National Beyond visual line of sight Experimentation Corridor  
Airspace Change Proposal

**Targeted Engagement report**

# Engagement report – Cranfield NBEC ACP

### 2.1 Proposed initial NBEC route

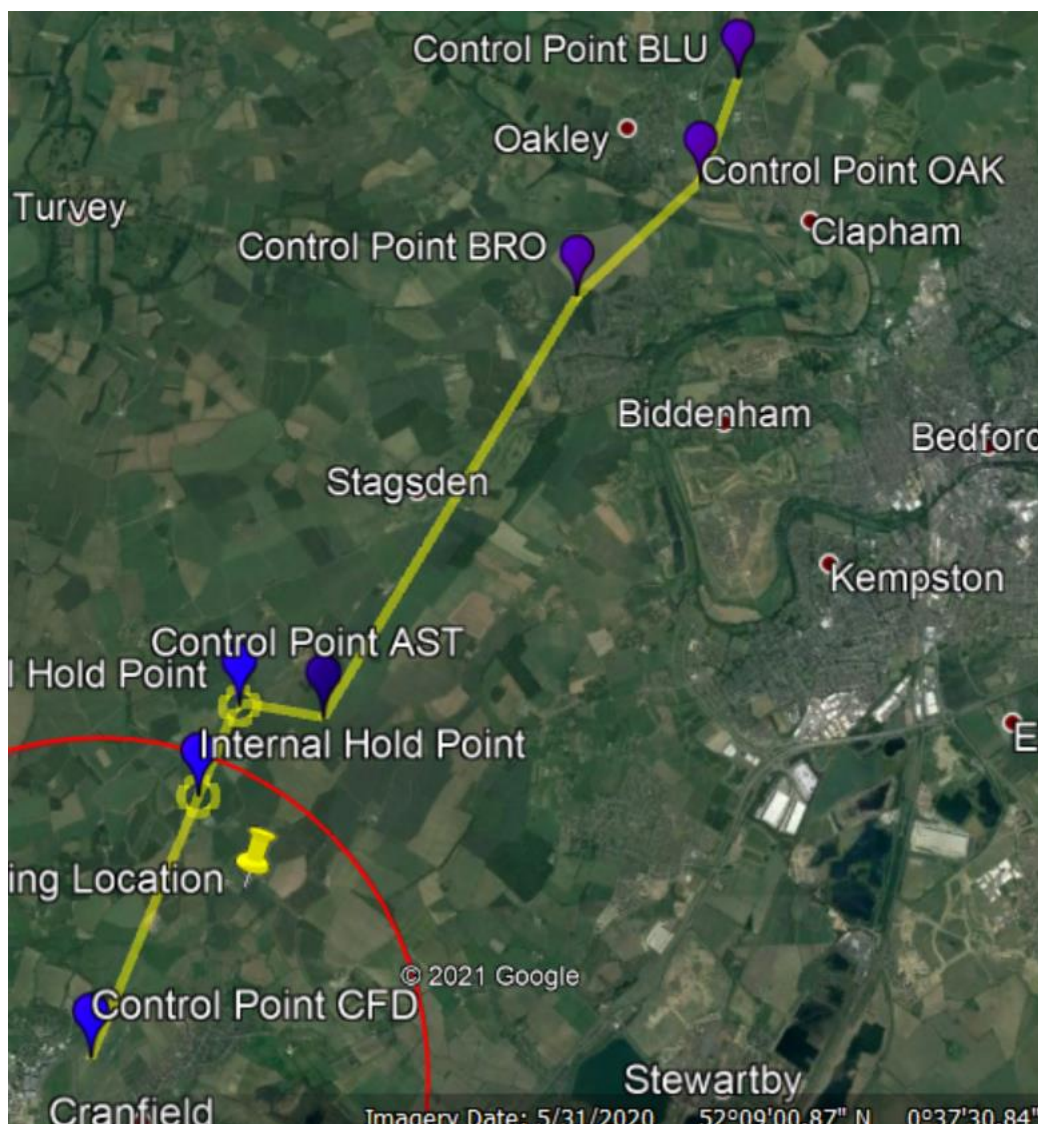
A further review of the route considering avoidance of villages was also conducted.

The image below shows the proposed NBEC flight path routing which has been reviewed and updated slightly in order to minimise overflight of residential areas, and to be coherent with operational procedures developed with Cranfield ATC:

This includes two 400 metre diameter circular hold points (small yellow circles), one inside the ATZ and one just outside.

- The airspace will be activated by NOTAM.
- NOTAMs will include contact details including Cranfield ATCs telephone number and frequency.
- NOTAMs will be published at least 24 hours in advance.
- Cranfield ATC will provide a DACS and a DAAIS as described in **Appendix E**.
- UAV flight path routing has been adjusted to minimise residential overflight.
